Contract No. T200312601.01
Federal Aid Project No. T200312601
SR 7, NEWTOWN ROAD TO SR 273
New Castle County

Enclosed is Addendum No. 1 for the referenced contract consisting of the following:

QUESTIONS AND ANSWERS

TYPICAL SECTIONS

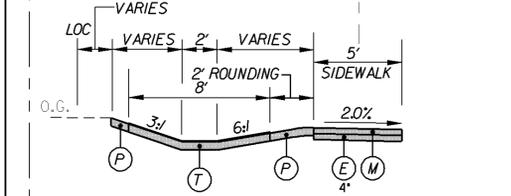
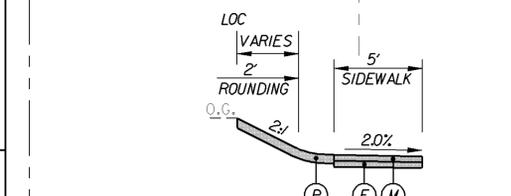
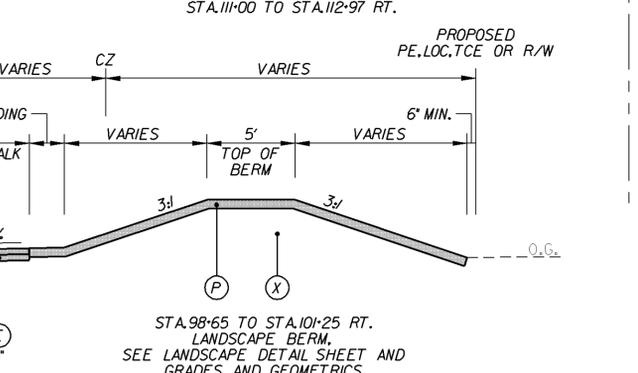
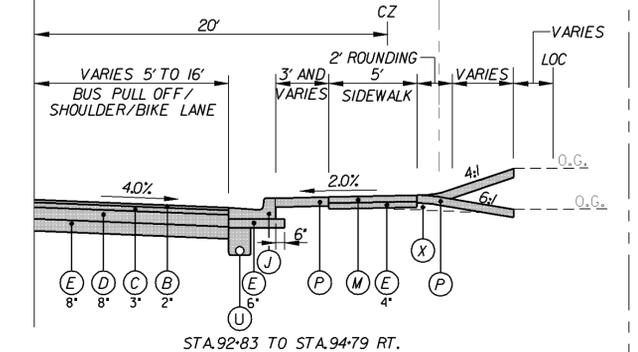
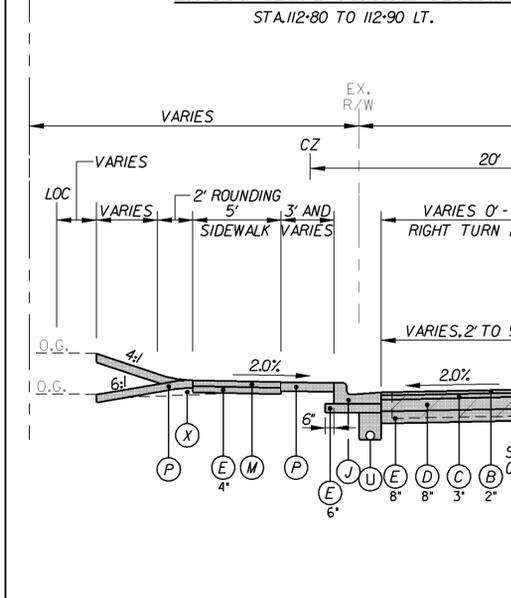
REVISIONS	
Δ	MODIFIED LEGEND:
	TAO/MJV 01/20/12

(U)	ITEM 715001 - PERFORATED PIPE UNDERDRAIN, 6"
(V)	ITEM 701027 - PORTLAND CEMENT CONCRETE CURB, TYPE 1, MODIFIED
(W)	ITEM 209001 - BORROW, TYPE A
(X) Δ	ITEM 209006 - BORROW, TYPE F SUITABLE EXCAVATED MATERIAL MEETING REQUIREMENTS OF BORROW, TYPE F

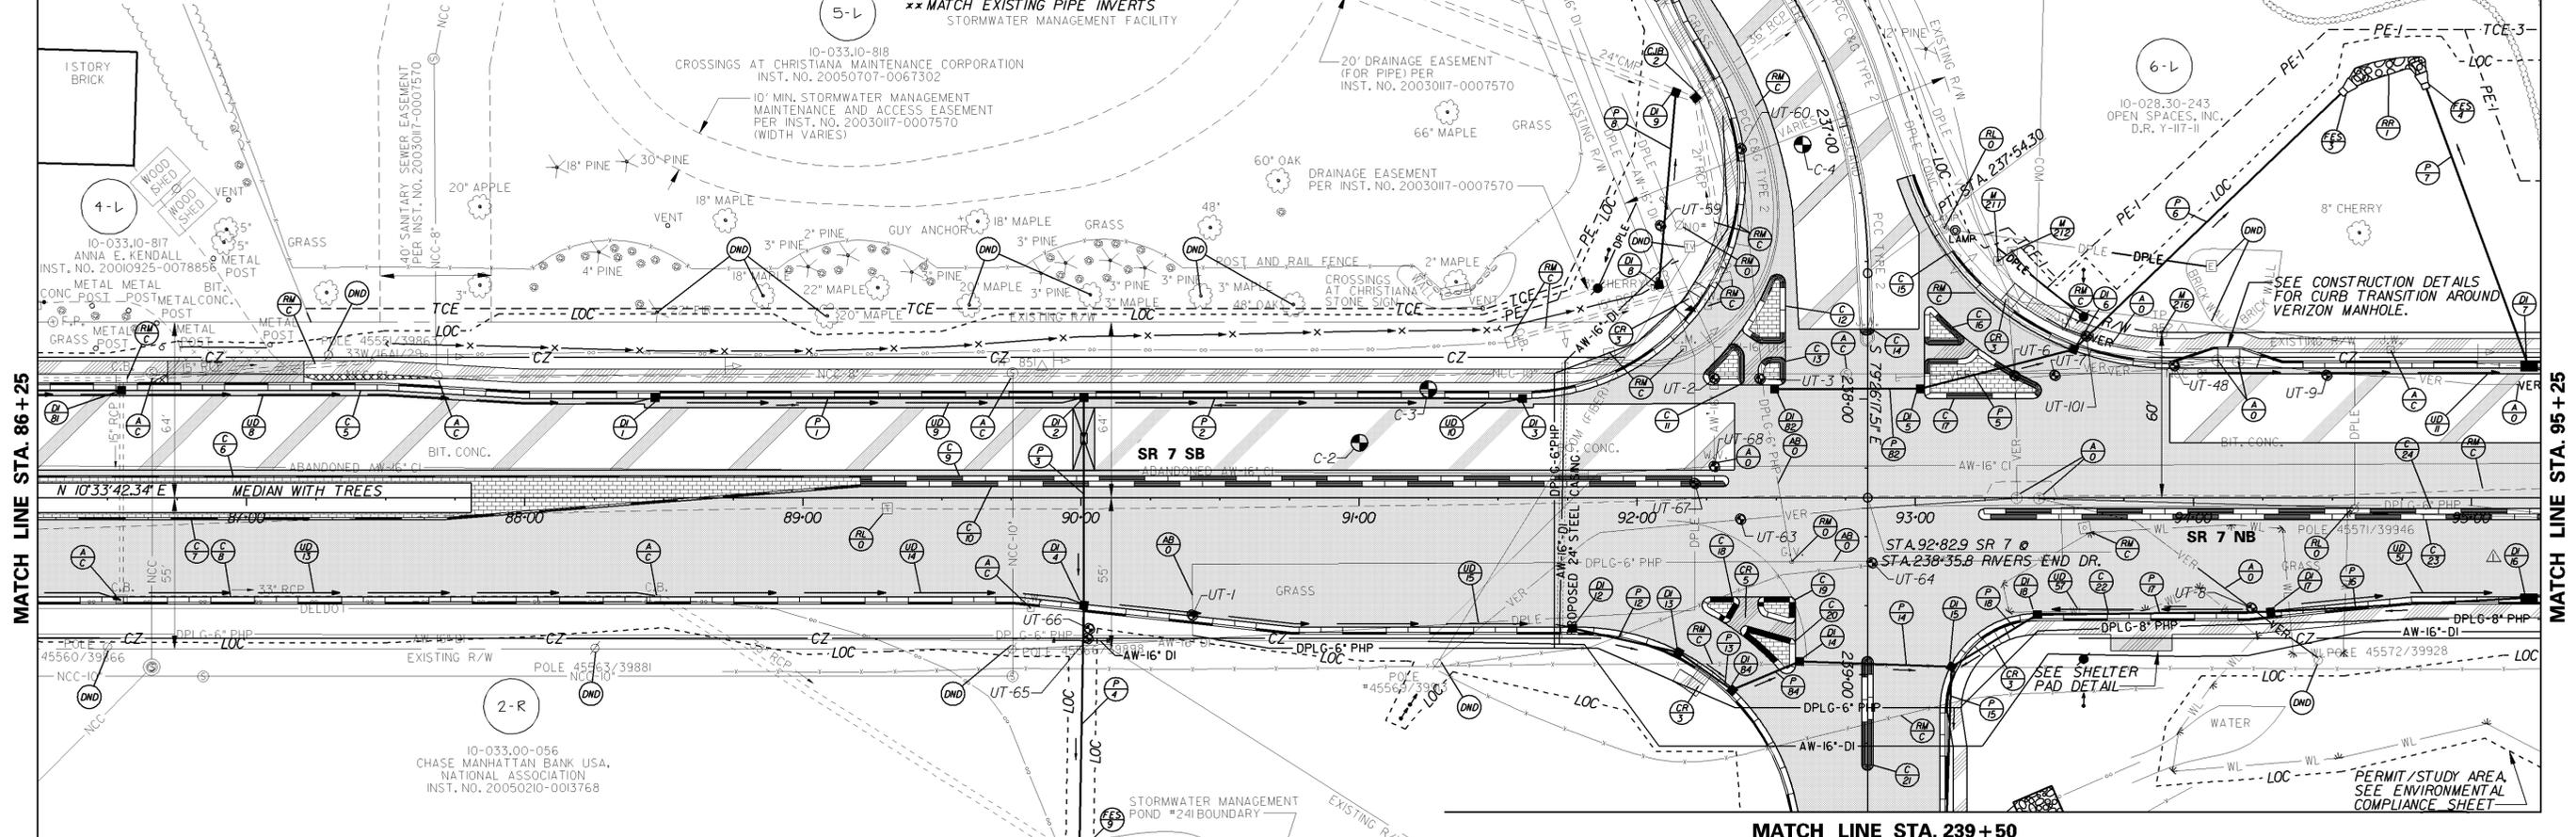
REVISIONS	
Δ	MODIFIED PIPE AND DRAINAGE
	INLET SCHEDULES:
	TAO/MJV 01/20/12

Δ MATCH FLOWLINE OF PROPOSED CURB AND GUTTER.
 ** MATCH PROPOSED CURBLINE
 CONVERT TO JUNCTION BOX SCHEDULE
 NO. TYPE INV. EL. STATION OFFSET
 2 15" 92-21J 145.2' LT.
 * SIZE OF BOX TO MATCH EXISTING
 ** MATCH EXISTING PIPE INVERTS
 STORMWATER MANAGEMENT FACILITY

PROFILES

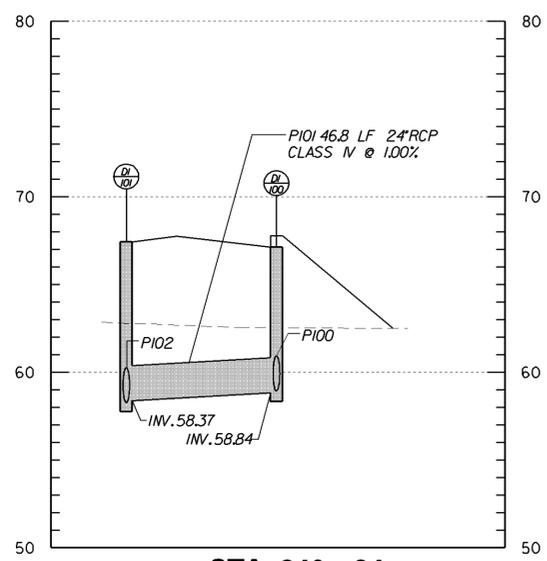
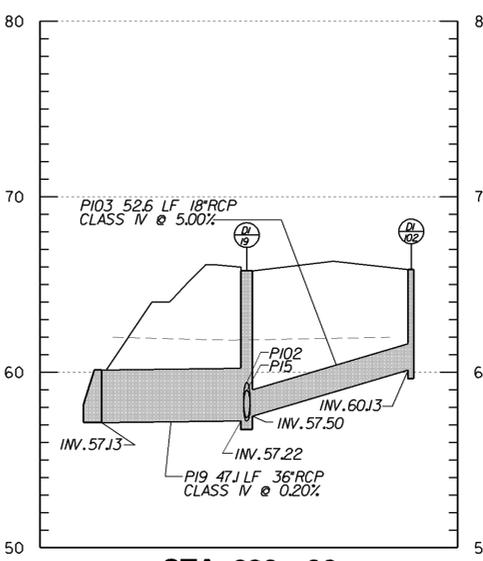
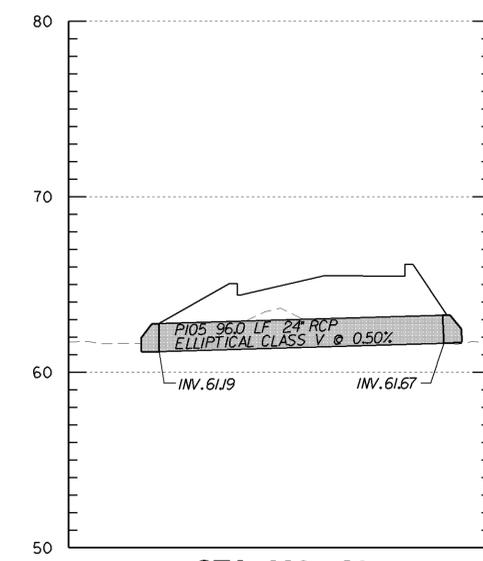
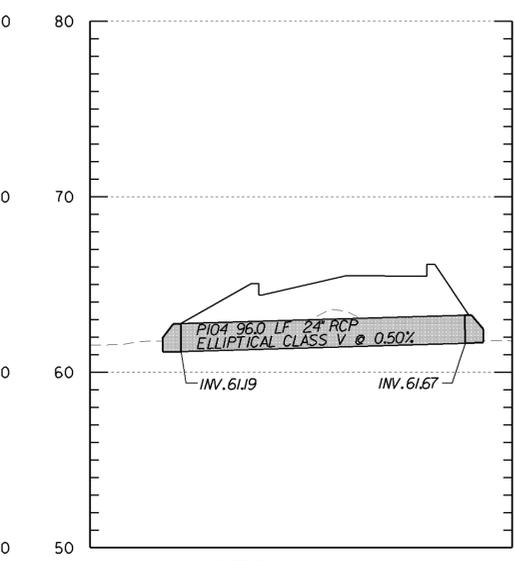
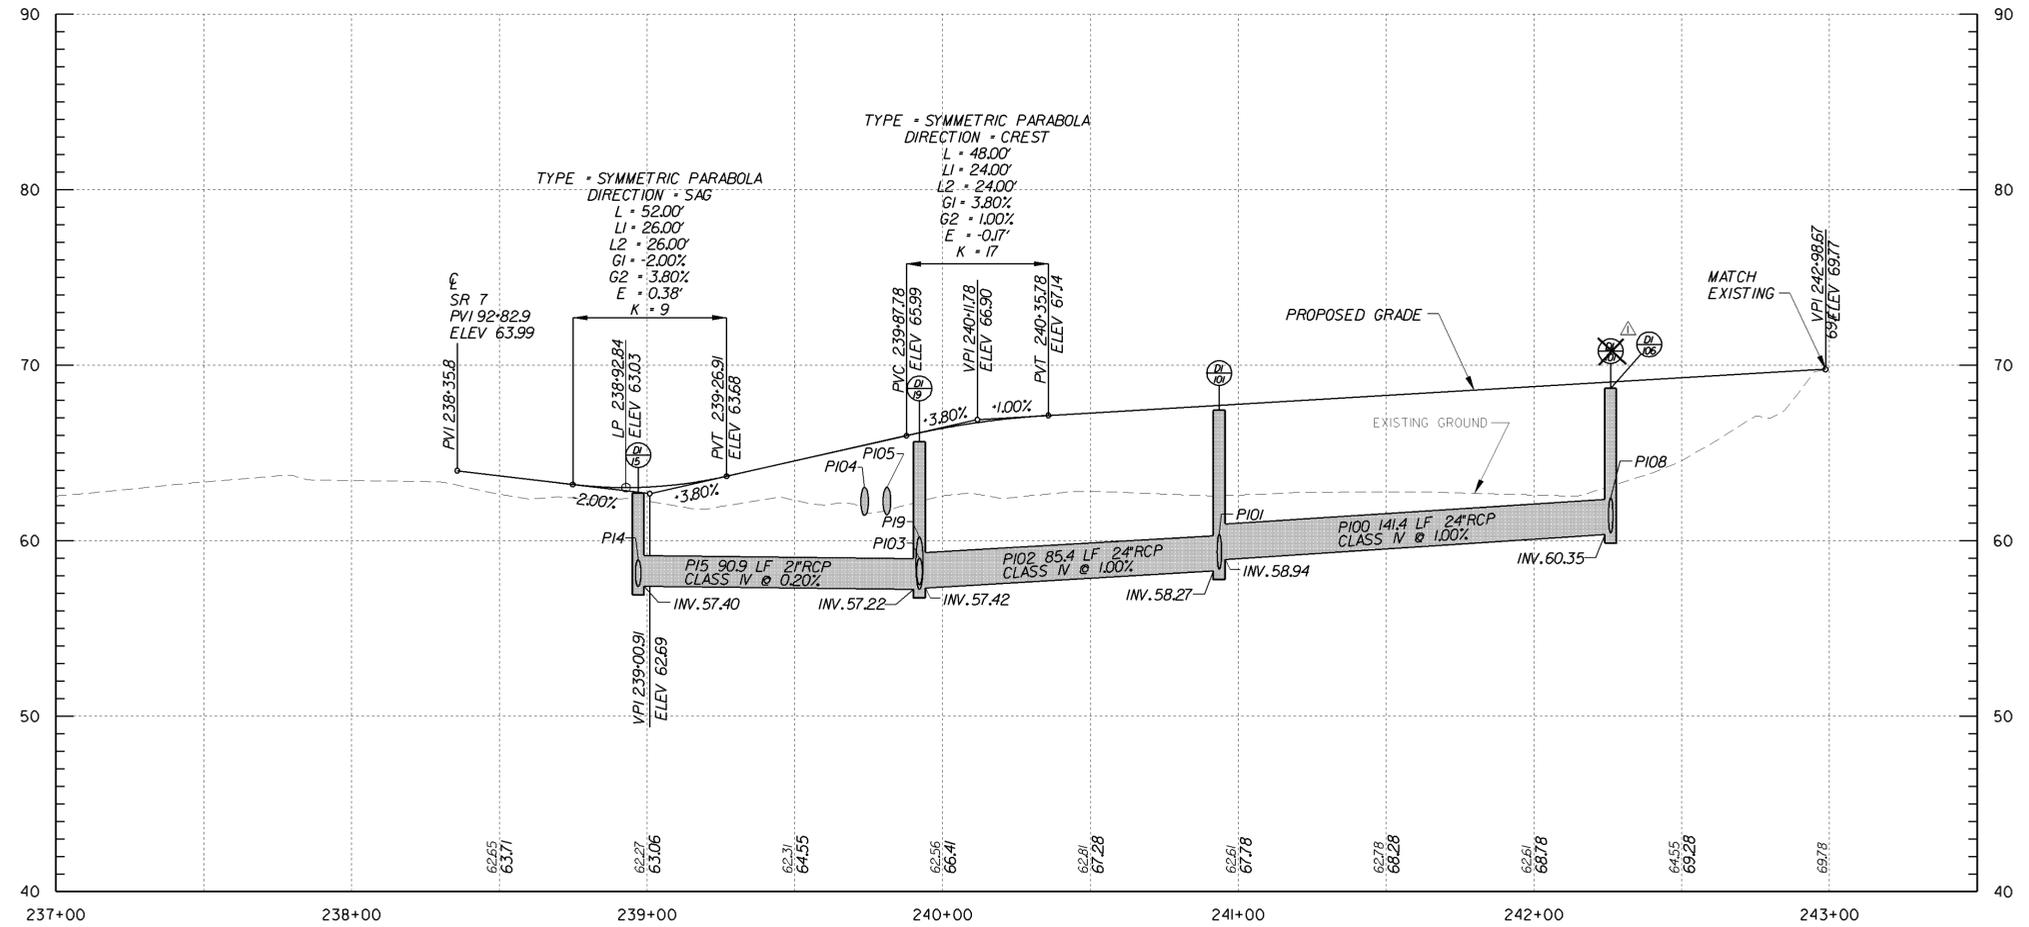
△ MODIFIED INLET IDENTIFIER;	
TAO/MJV 01/20/12

CONTRACT	COUNTY	F.A.P. NO.	SHEET NO.	TOTAL SHES
T200312601	NEW CASTLE	SEE TITLE SHEET	49	115

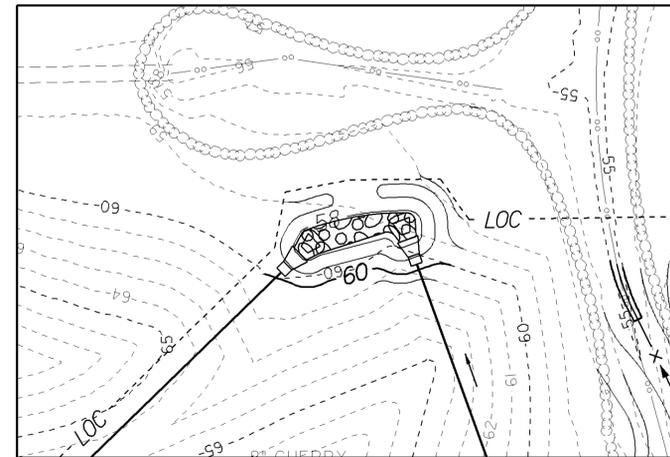
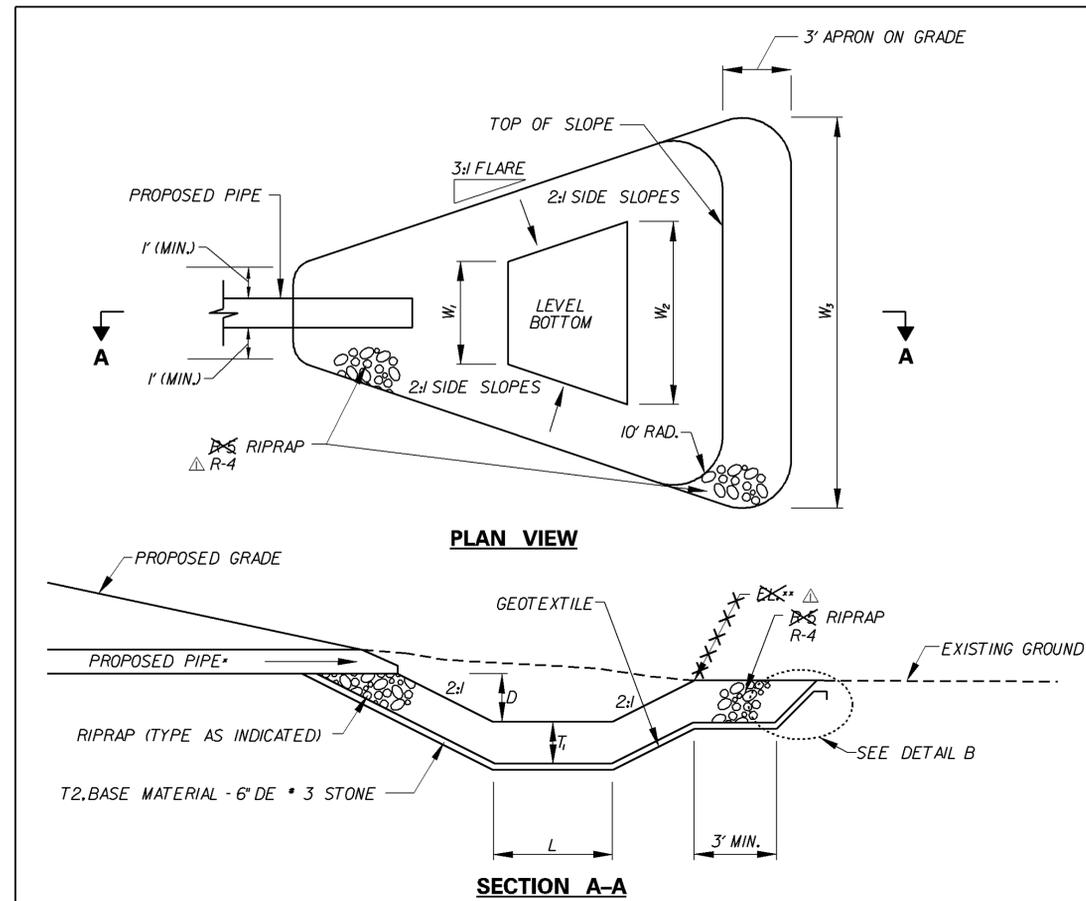
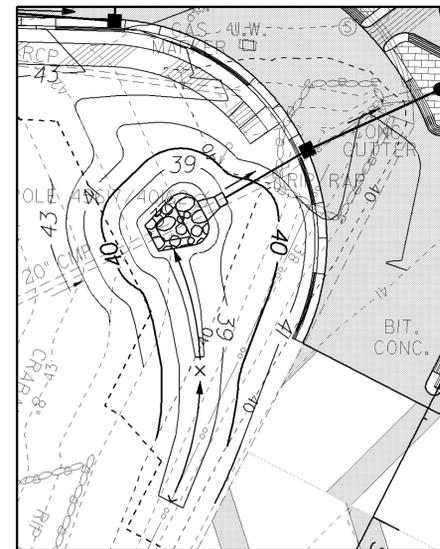
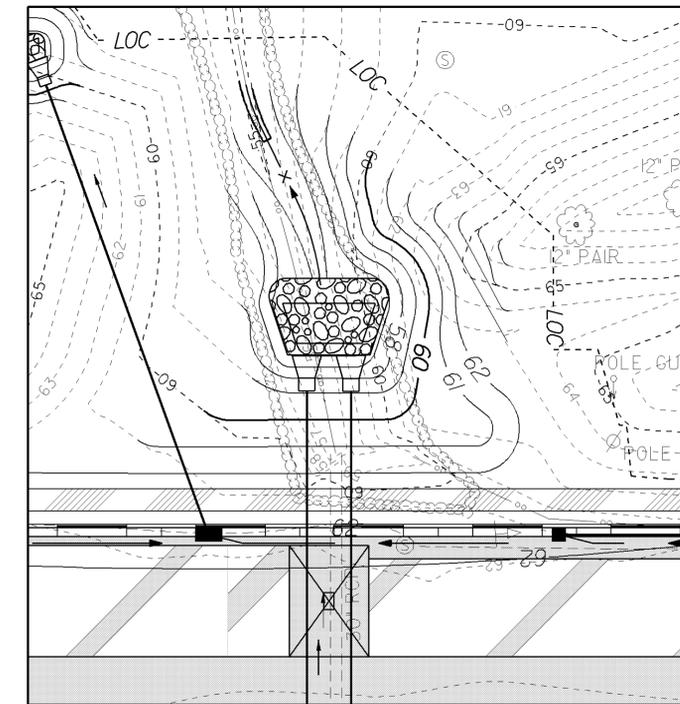
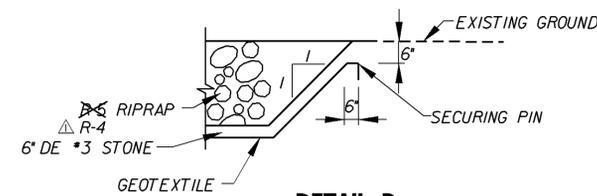
4	The bid form item #712005 is listed as R-4 Rip Rap, but the construction details on sheet 49 of 115 state that the rip rap size is R-5. Please clarify the rip rap size required for this project.	R-4 Rip-rap is to be used. R-4 is shown on the construction sheets that correspond to the pipe energy dissipater locations and the rip-rap on the construction detail sheet (49 of 115) should read R-4, not R-5.

△ CHANGED RIPRAP FROM R-5 TO R-4 FOR PIPE DISSIPATOR;	
TA0/MJV 01/20/12

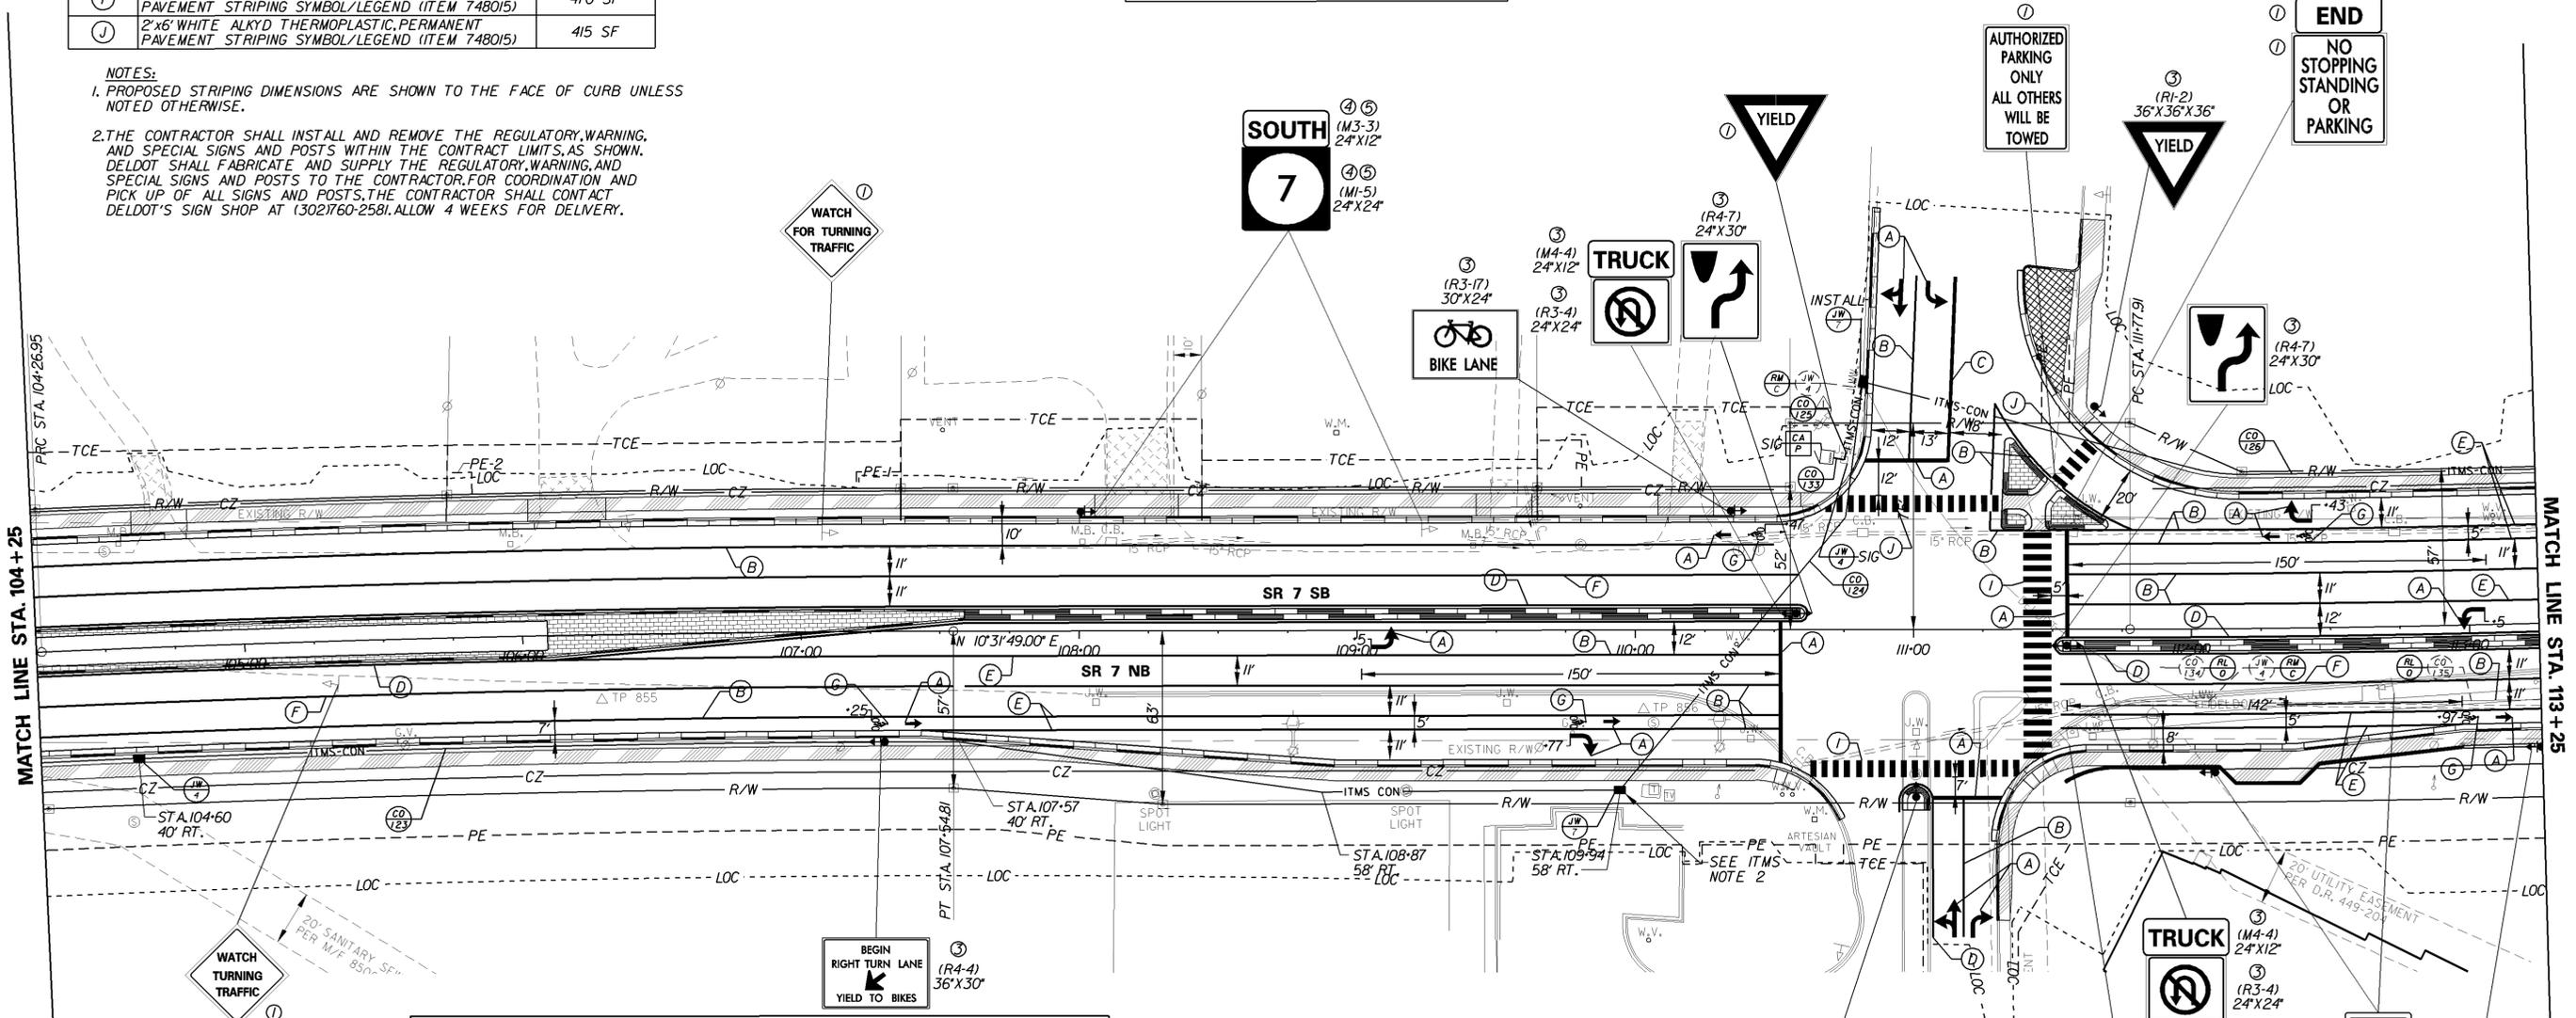
13	Signing striping and conduit Plan number 101 of 115 in regards to Co-125. The indicator on the plans states that it is existing conduit but the schedule indicates new conduit. Can you please advise.	Co-125 is a proposed conduit run. The identifier for this conduit is incorrectly patterned existing.
12	On plan sheet 30 there are two (2) DI-101 shown (Entrance Road Profile)	The DE at approximate station 242+25 should be labeled DI 106. Will be addressed in addendum #1.
11	Quantities for item 708051 and 708053 do not appear to be correct	Items have been adjusted. Item 708051 now has a quantity of 21 and 708053 has a quantity of 9. This will be addressed in addendum #1.
10	Quantities for items 612021, 612022, 612030, and 612033 do not appear to be correct.	Items have been adjusted. New quantities are as follows: 612021-1088 LF, 612022-4882 LF, 612030-306 LF, 612033-189 LF. Will be addressed in addendum #1.
